ATTACHMENT A

Revise the Technical Specification pages as follows:

The Cycle 19 reload has been designed by Westinghouse using standard design methodology. Based on this methodology, all criteria for the reload are met provided a slight adjustment is made to the bank D insertion limits. This Technical Specification change will slightly modify the rod insertion limits for Cycle 19 to ensure all criteria are met.

FIGURE 3.10-1

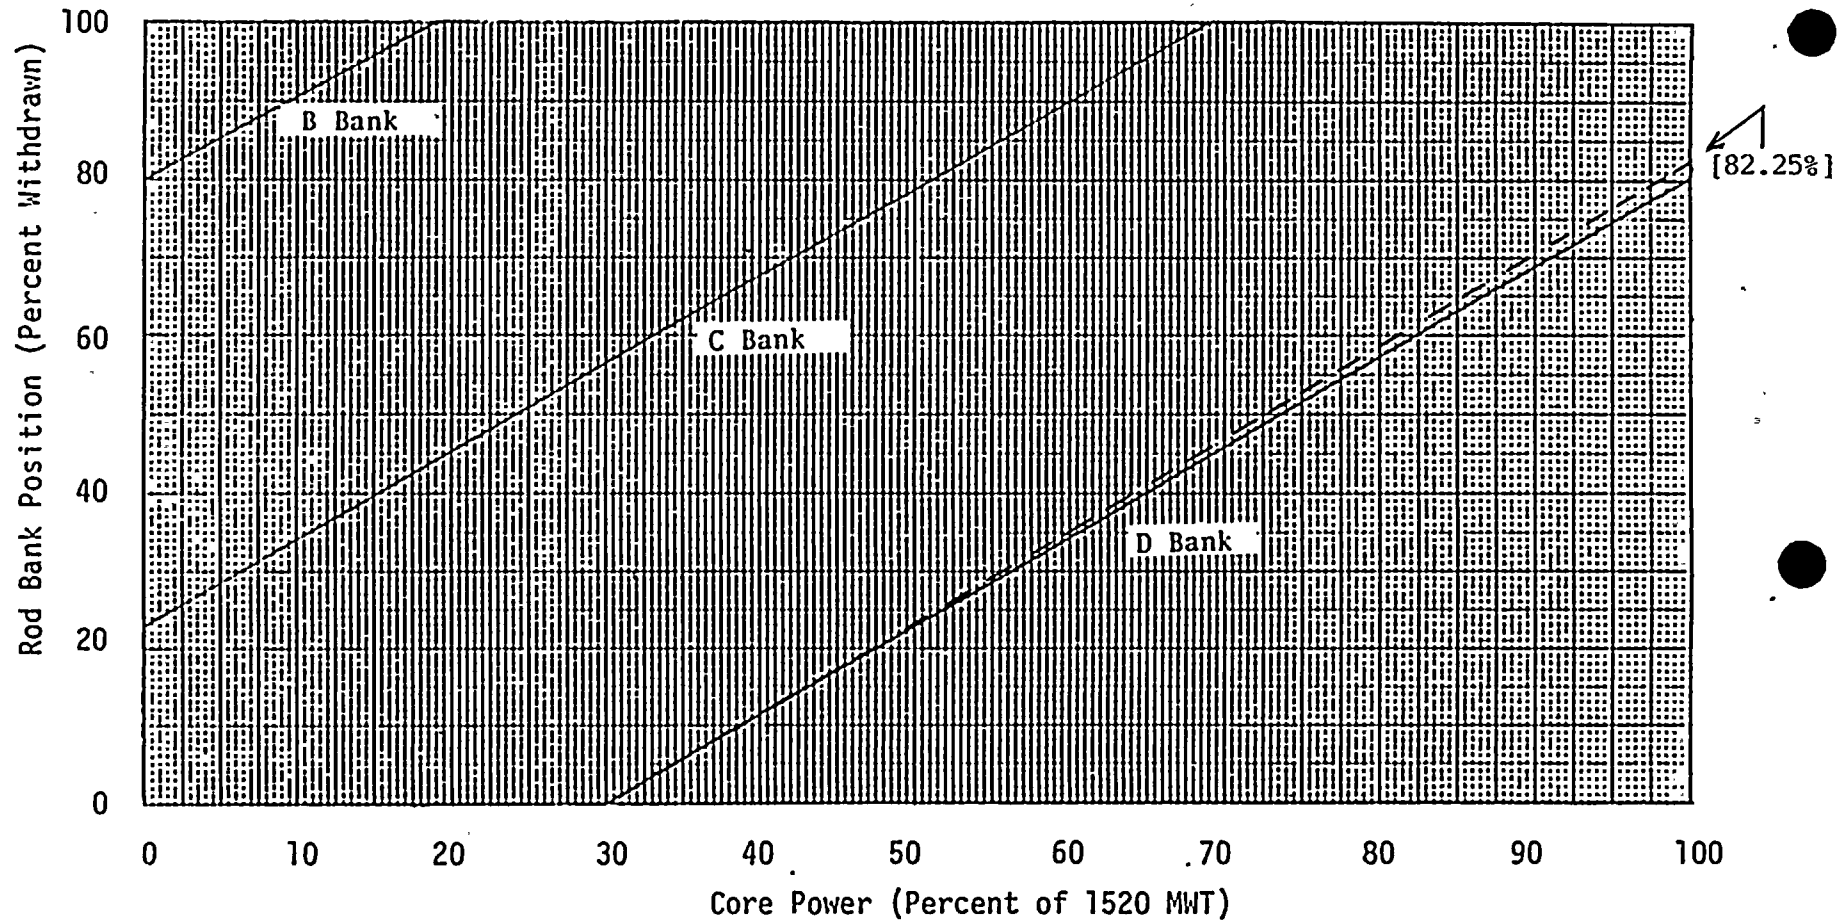
[----- Dashed line is applicable only for Cycle 19 with cycle burnup greater than 5250 MWD/MTU providing Cycle 18 burnup has exceeded 12150 MWD/MTU.]

The adjustment is illustrated on proposed Technical Specification Figure 3.10-1. The adjustment is only necessary for Cycle 19 provided Cycle 18 exceeds a burnup of 12150 MWD/MTU and is only applicable for Cycle 19 burnups from 5250 to 9500 MWD/MTU. (Since 9500 MWD/MTU is close to Cycle 19 end of cycle the 9500 has been extended to end of cycle for this application).

As stated in the attached Reload Safety Evaluation the amount by which the  $1.66 F_{\Delta}$  limit could be exceeded with the current insertion limits varies from 0% at a Cycle 18 burnup of 12150 MWD/MTU to a maximum of 0.33% at a Cycle 18 burnup of 12300 MWD/MTU. The limit is not exceeded if the bank D insertion limit is raised by 2.25% (5 steps) at full power as illustrated on proposed Technical Specification Figure 3.10-1. Since this change is not applicable to future cycles, it is presented as a change with a limited period of applicability on proposed Figure 3.10-1 with appropriate qualifiers. No other safety criteria are affected by the Cycle 19 core reload.

The proposed change would require the bank D control rods to be withdrawn 5 steps further during full power operation. Withdrawing the rods above the insertion limit increases the shutdown margin, decreases the ejected rod worth, reduces power peaking, and does not alter stuck rod worth. Therefore, withdrawing the rods is conservative and ensures that the safety criteria for the Cycle 19 reload are met, there is no significant increase in the probability or consequences of an accident previously evaluated. Ensuring the criteria are met does not create the possibility of a new or different kind of accident or result in a reduction in a margin of safety.
